HISTORIC AND DESIGN REVIEW COMMISSION

Agenda Item No: 13

HDRC CASE NO: 2016-396
ADDRESS: 1602 N ZARZAMORA
LEGAL DESCRIPTION: NCB 2085 BLK 25 LOT 13 AND 14
ZONING: I-1 HL
CITY COUNCIL DIST.: 1
LANDMARK: Yes
APPLICANT: Alex Gonzalez/Alex Gonzalez Architect LLC
OWNER: Esperanza Peace & Justice Center
TYPE OF WORK: Window replacement, installation of a canopy, structural improvements
REQUEST:

1 Wall Section
SCALE: $3/8" = 1'-0"$

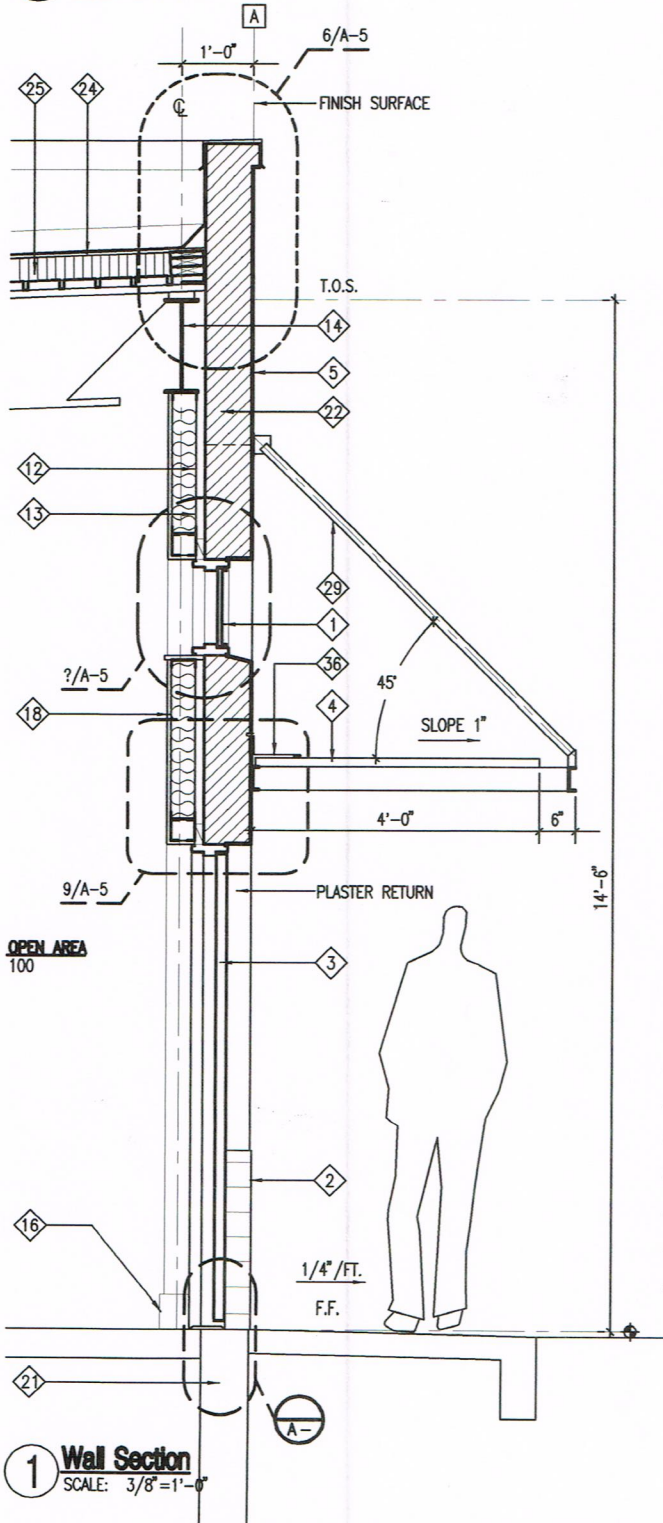
- b. WALL AND ROOF - The applicant is proposing to remove and re-install the rear wall and roof. According to the Guidelines for Exterior Maintenance and Alterations, repairs to masonry should be done by a professional. Staff finds this repair appropriate and consistent with the Guidelines.

- d. CANOPY - There is an existing mansard awning over the fourth bay and a horizontal banding; there is not an existing full length canopy. The applicant is proposing to remove the existing mansard awning and horizontal banding and install a front steel canopy in its place with cable supports along the full west, front façade,. According to the Guidelines for Exterior Maintenance and Alterations 10 and 11, new awnings should be added based on accurate evidence of the original. Staff finds based on historic photos and the statement of significance, an awning would be appropriate and consistent with the Guidelines.

Staff recommends approval based on findings a through h with the following stipulations:

1. That the applicant provide a photo example of the tiles to be installed.
2. That landscape details be provided to staff at a later date when available, to receive a Certificate of Appropriateness.
3. That the applicant submit locations of the proposed light fixtures to staff prior to receiving the Certificate of Appropriateness.
4. That the applicant submit a paint swatch to staff prior to receiving the Certificate of Appropriateness.
